Interactive comment on “Estimating net anthropogenic nitrogen inputs (NANI) in the Lake Dianchi Basin of China” by W. Gao et al.

Received and published: 17 June 2014

Fig. 1.

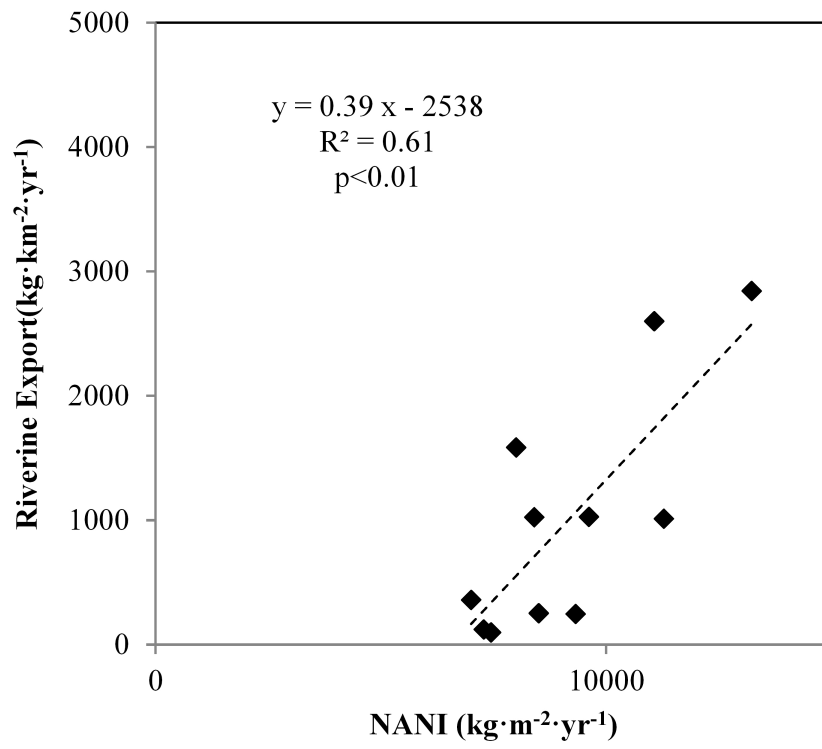
(1) “My wondering point is why you used date of catchment 4, 8 and 14 to make this figure. The catchment of 4, 8, and 14 are exactly different to others in population density and the percentage of urban area. Further, in these catchments, the distance from water treatment plan to water sampling point looks too close to discuss the purification capacity. If you make figure 5 without these three catchments, you will find more good fitting line between NANI and Riverine Export in Fig. (b). Also you will find different value of slope, and y-intercept of the linear fit function. For my roughly estimation, the slope value looks around 0.2 that is not so different value in North America and Europe (the last line of page 6). Also, intercept of X axis might be shifted to small value. If so, your discussion in page 7 will be no point.”

(2) "I think that your mistake to make Fig. 5 with all catchment data itself is showing one kind of important reminder or carefully point for using NANI to small area."

tion and food & feed imports. While it is true that these three watersheds have the highest population density and proportion of urban land, the aim is to use a single methodology to estimate N inputs irrespective of the character of the landscape, and to eliminate these watersheds would remove the urban end of the spectrum from the analysis. For the three catchments, the high percentage of human population density and urban area indicate that human activities in these areas are very intensive, which is consistent with their high NANI values. If, as you suggest, we delete these three catchments from figure 5 (please see the attached figure 2), a poorer rather than better fitting line results. The slope is still very high (0.61) and the intercept is negative ($p < 0.05$), which is consistent with our current results. Instead, we have chosen to examine the effect of estimating the untreated riverine fluxes for these relatively urban watersheds (see reply to comments of reviewer 1), and feel that this approach supports our conclusion about the importance of waste treatment in such systems.

Authors' response: While we agree that dealing with relatively small watersheds is a challenge, we note that watersheds 4, 8 and 14 are not the smallest in the set considered. As noted above, we believe it is important to include the urban watersheds in the analysis even if the high resulting loads influences the result. Further, we think that we have identified an issue perhaps as important as scale in the relationship between NANI and riverine N flux: the extent of N removal in waste treatment in areas of high population density.
